From: Nancy McLaughlin
To: Ed Anzek
Date: 1/7/14
Re: File No.: 14-015
Project: Taco Bell @ M-59/Avon Industrial Review #2
Applicant: Guggenheim Real Estate Partners

From: Craig McEwen, Building Inspector/Plan Reviewer
To: Sara, Roediger, Ed Anzek, Planning Department
Date: December 2, 2014
Re: Taco Bell @ M59/Avon Industrial – Review #2
Sidwell: 15-29-276-005
City File: 14-015

From: Sara Roediger, AICP
Date: 1/7/2015
Re: Taco Bell at M-59 & Avon Industrial (City File #14-015)
Preliminary/Final Site Plan - Planning Review #3

From: Jason Boughton *JRB*
To: Sara Roediger, Manager of Planning
Date: December 23, 2014
Re: Taco Bell @ Crooks & M59, City File #14-015, Section #29
Site Plan Review #3

**REPLAT NO. 2
STAR-BATT CONDOMINIUMS**

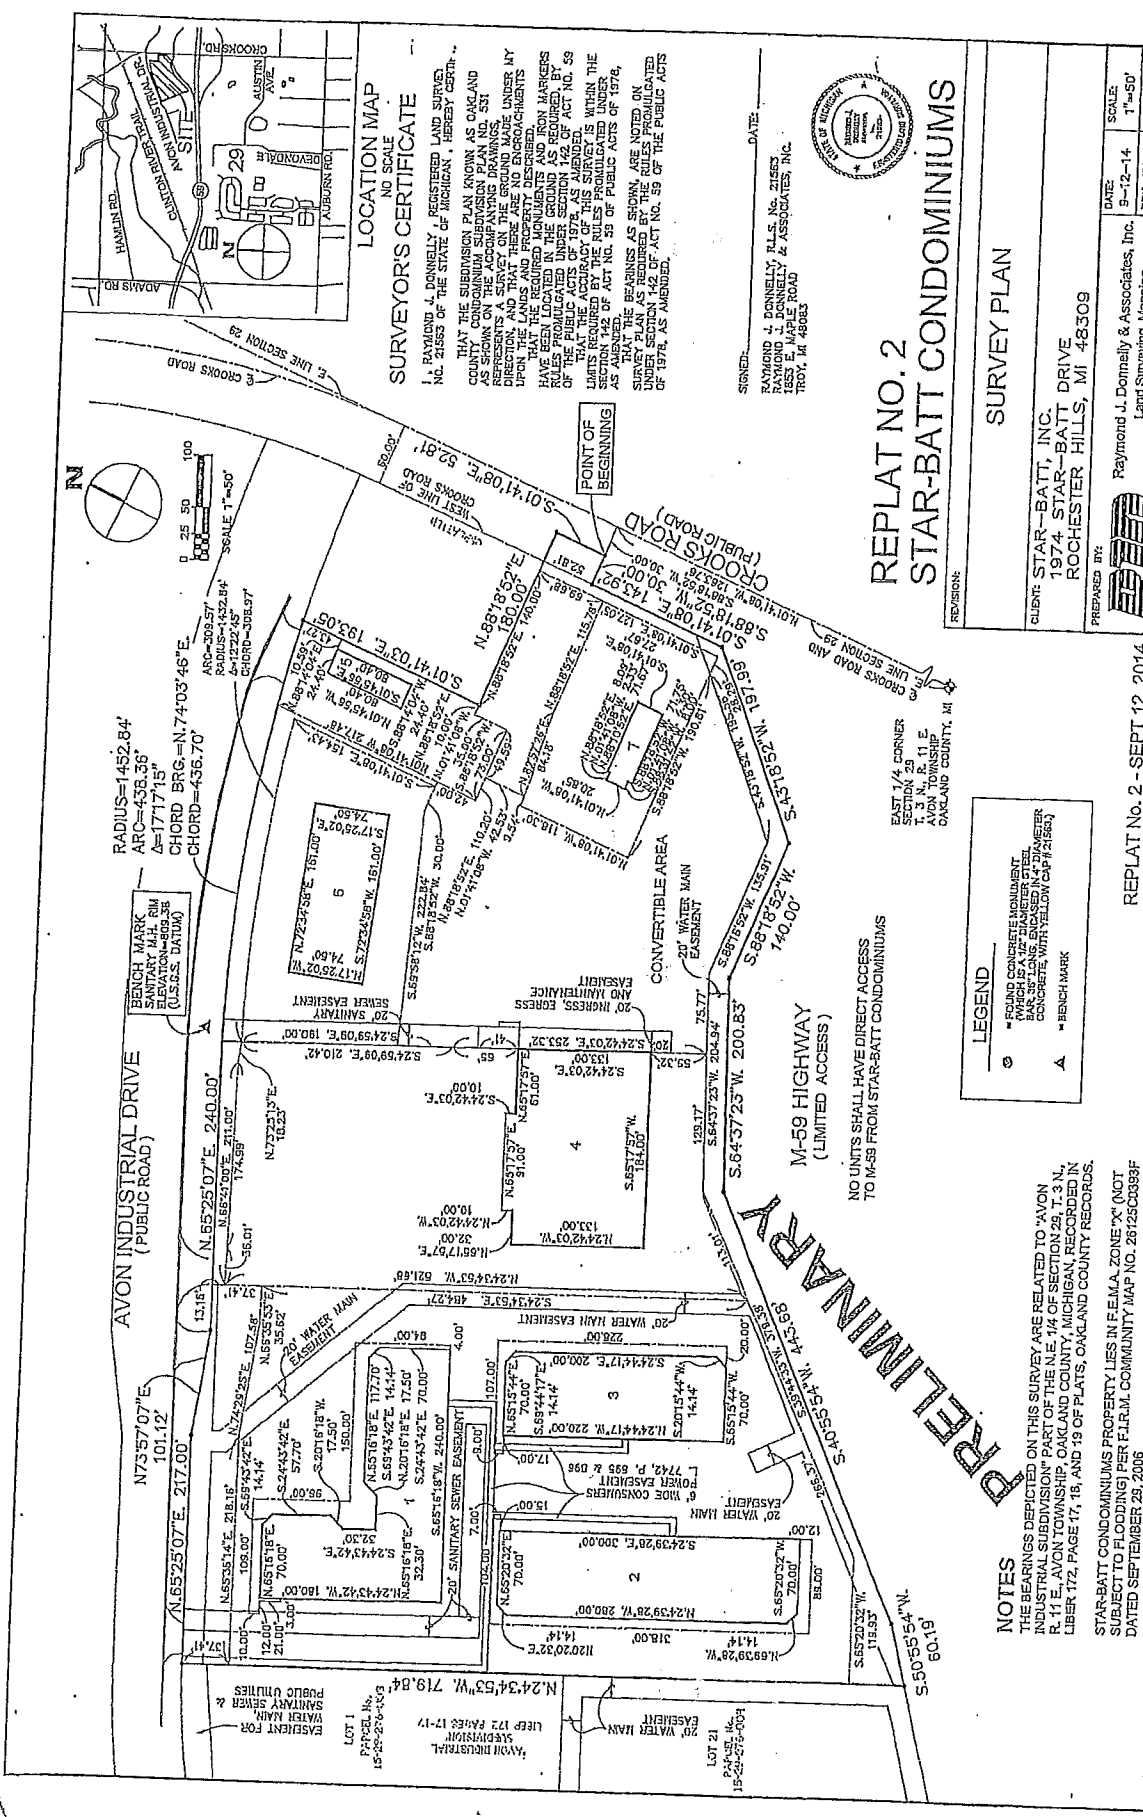
1. Coordinate the proposed offsite easements for the storm sewer and sanitary sewer with the Replat No.2 of Star-Batt Condominiums. (see attached)
